PARTSCAP

Stop Arm Changes SE2 (Electric) & SA1 (Air)

April 2019

SE2 Electric - Incandescent Light

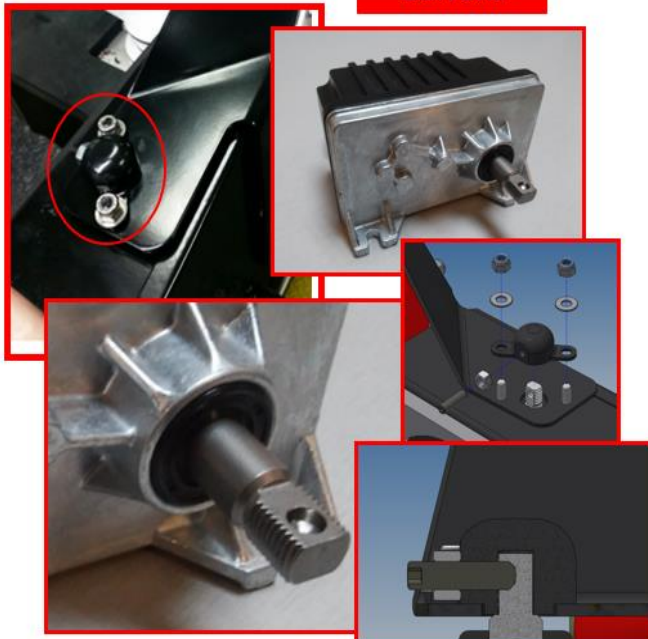
Only Change is to the motor and hub

Motor Update

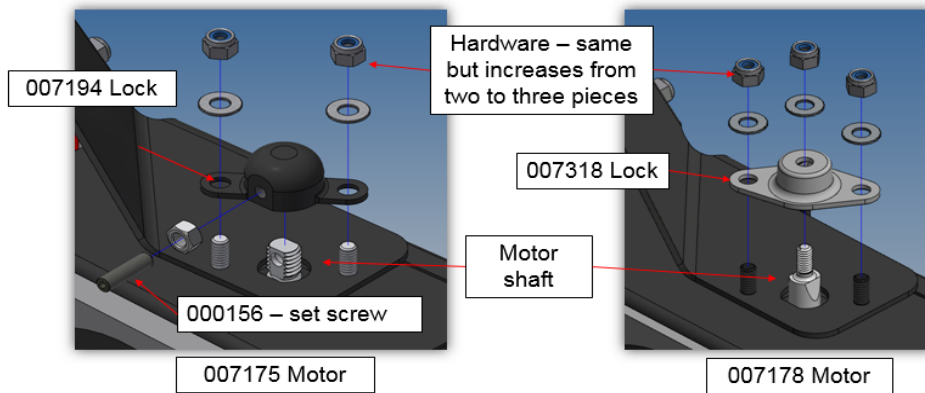
- New motor (007178 tapered shaft) is direct replacement for current (007175 flat shaft)
 - 007175 replaced by 007178K
 - 007175 (current / flat shaft motor) uses 007194 and 000156 set screw
 - 007178K (tapered shaft) uses 007318 replaces 007175
